SIB 61 05 21

SERVICE ACTION: WIRE ROUTING ADJUSTMENT

2021-03-23

MODEL

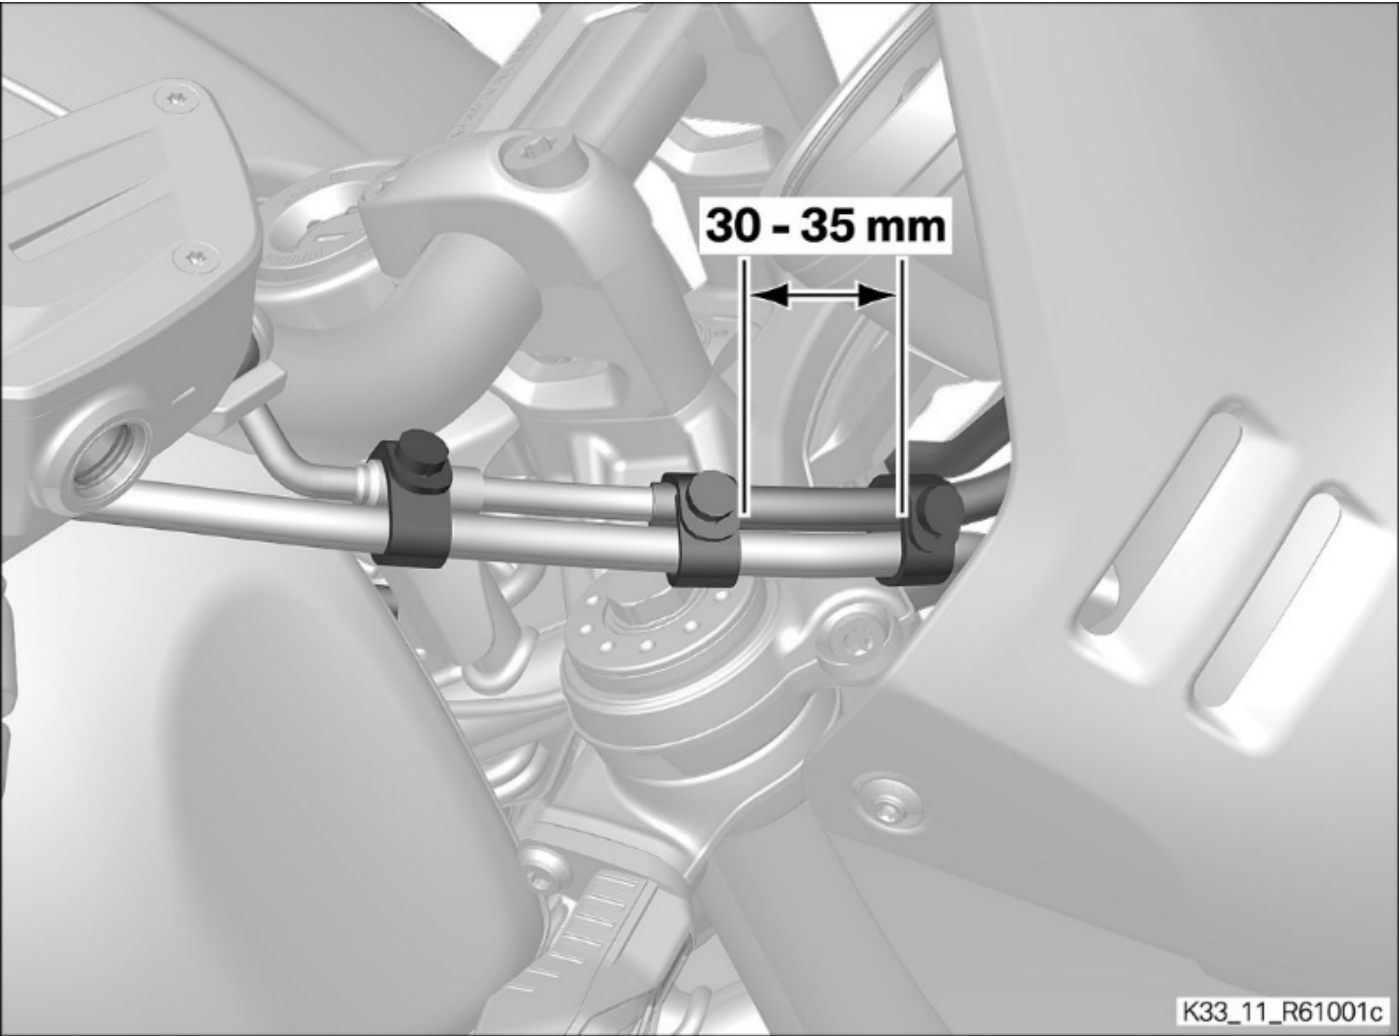
The bands holding the wiring harness in the area of the steering head are positioned incorrectly from the factory. This can cause rubbing against the steering head at maximum steering angle and could eventually cause damage to the surface of the steering head.

Position the bands as illustrated in the image below.

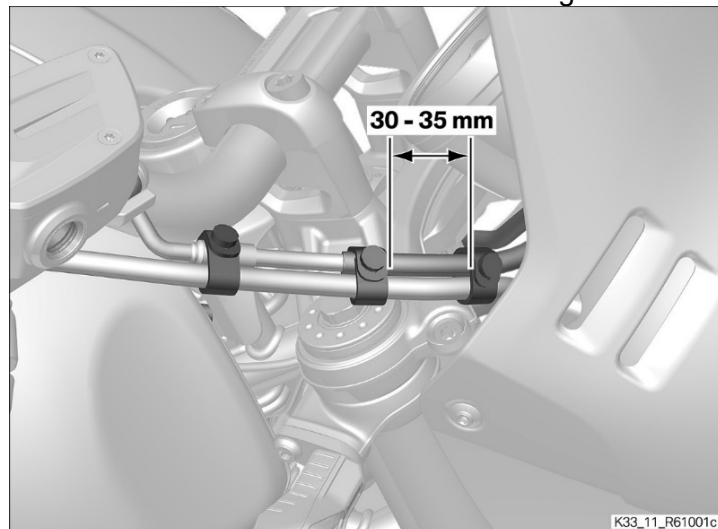
The bands holding the wiring harness in the area of the steering head are positioned incorrectly from the factory. This can cause rubbing against the steering head at maximum steering angle and could eventually cause damage to the surface of the steering head.

Position the bands as illustrated in the image below.
